Appendix 2 – Plans and images

Appendix 3 Consultation Responses from internal and external agencies

Stakeholder	Question/Comment	Response
INTERNAL		
Design	<p>Thank you for asking me to comment, I have been closely involved with this application all the way through the pre-application discussions, Quality Review Panels, and subsequent meetings, and am very familiar with the issues and constraints.</p> <p><u>Summary</u></p> <p>These proposals are a sophisticated and subtle response to what could be a challenging site, that achieves a design of exceptionally high quality, appropriate to context and promising to provide superb new homes. They bring back into use an architecturally notable former police station that acts as a local landmark, positive contributor to the conservation area and marker of a potentially attractive and important urban space. They then fill in the undesirable gaps at either side of the former police station in what promise to be striking, innovative, distinctive and unusual contemporary buildings that are nevertheless designed to complement their locations and settings on appropriate forms for their character. Provided sufficient quality is followed through

Proposed roof plan

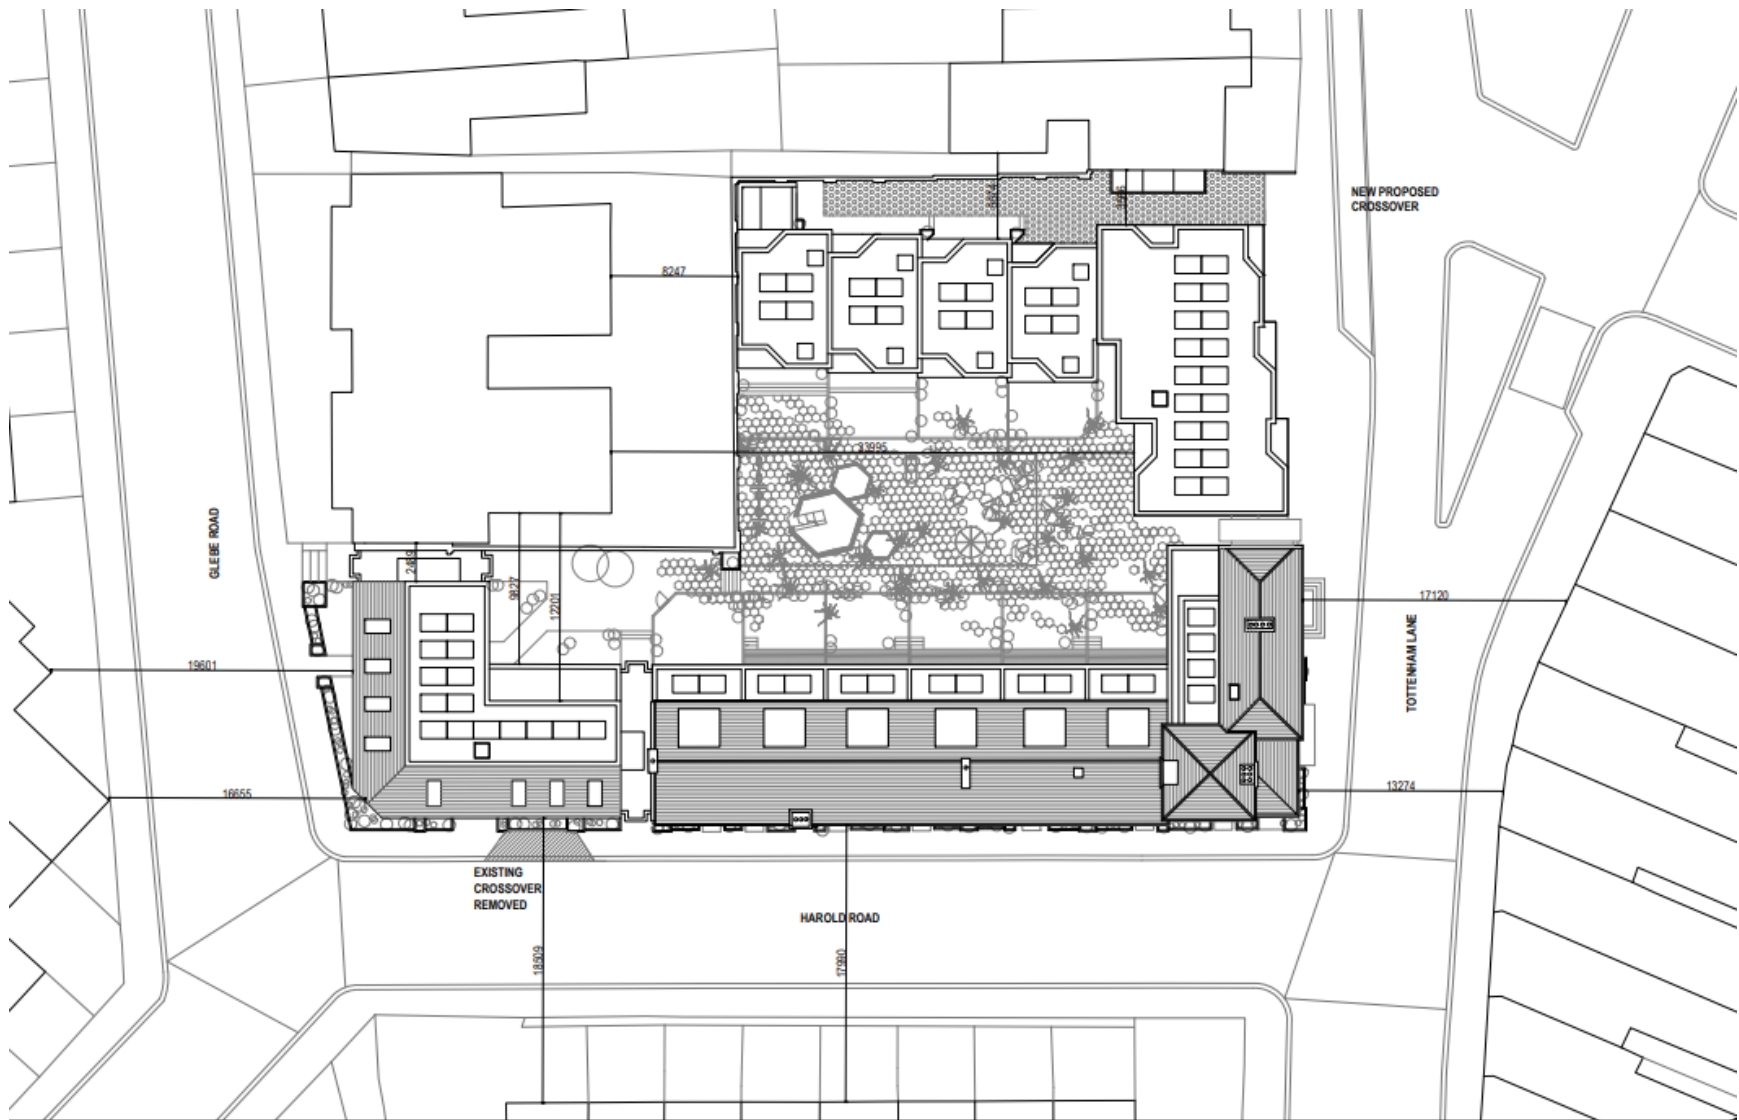
The applicants have noted that there will be living roofs and living walls (ref para 7.22 of energy statement and s3.2 of BNG Report) in the scheme, but no evidence has been submitted. Plan ref: 044_A-114 does not indicate annotation for living roofs, solar PV, and any plant equipment on the roof.

- Please provide annotated plans including the living roofs, solar PV, and any plant equipment proposed on the roof.
